memo

DATE: November 18 for the December 3, 2015 Meeting

Case #2015-103. Vista Serena, Tract 49 Tierra Contenta, Prelim. Subdivision Plat.

DESIGN ENGINEER
 VISTA SERENA
 STREET LIGHTING PLAN

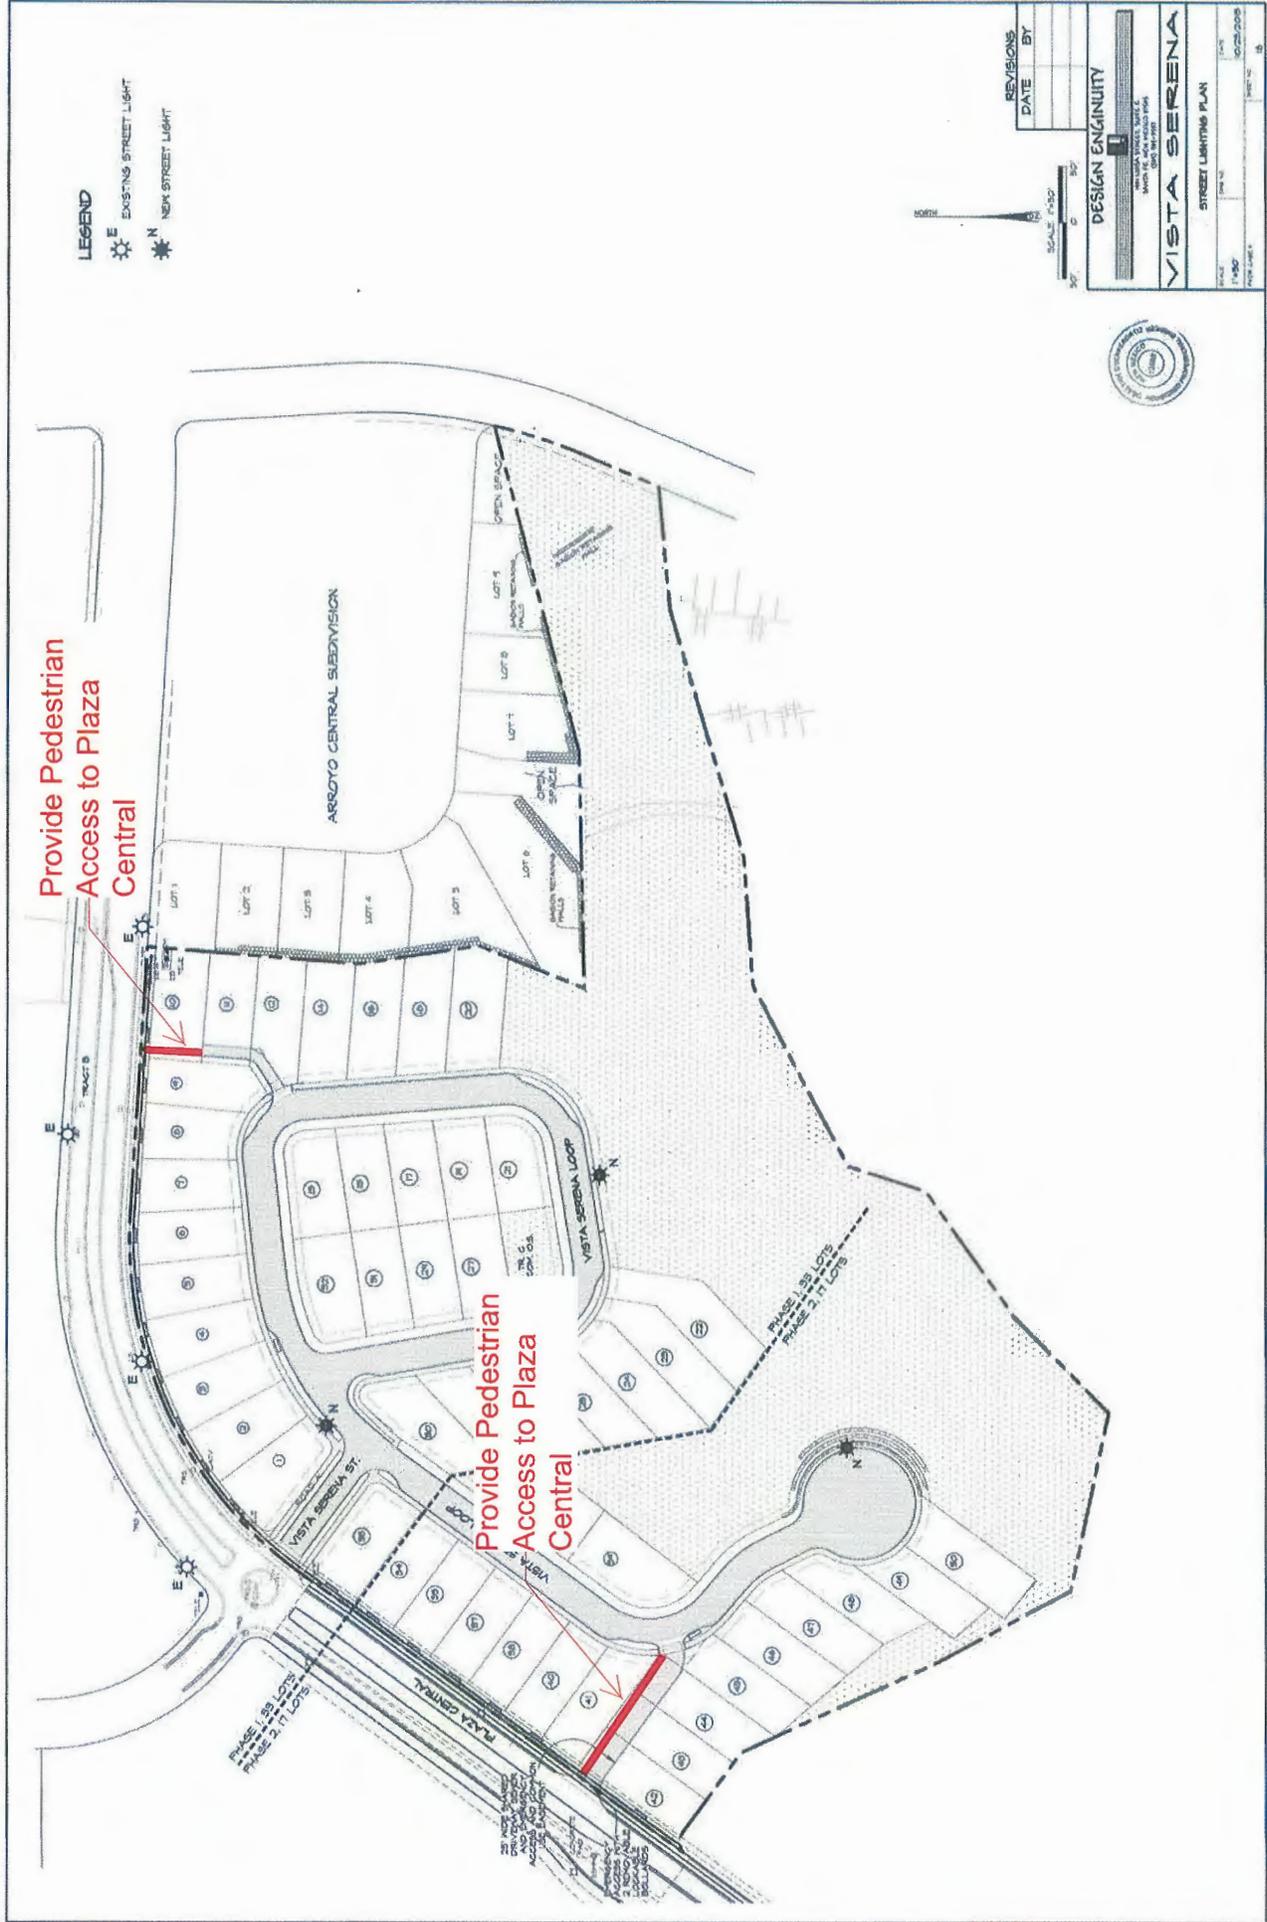
Oralynn is asking for me to drop the pedestrian connection to the east by lot 10 due to grade issues that she says will require steps. I am reluctant to do this due to the importance of providing good pedestrian connectivity, although would be happy with a pedestrian connection between lots 6 through 9. Based on code or the Tierra Contenta Design Criteria do I have a justification to require them to provide this pedestrian connection?

Additionally, I will be asking for pedestrian connections from the subdivision to Plaza Central at the east and western ends (see attached). I am not sure if this raises to the level of a request for additional submittal, but it may be helpful to provide to the applicant now to allow them to respond.

Provide Pedestrian
 Access to Plaza
 Central

Provide Pedestrian
 Access to Plaza
 Central
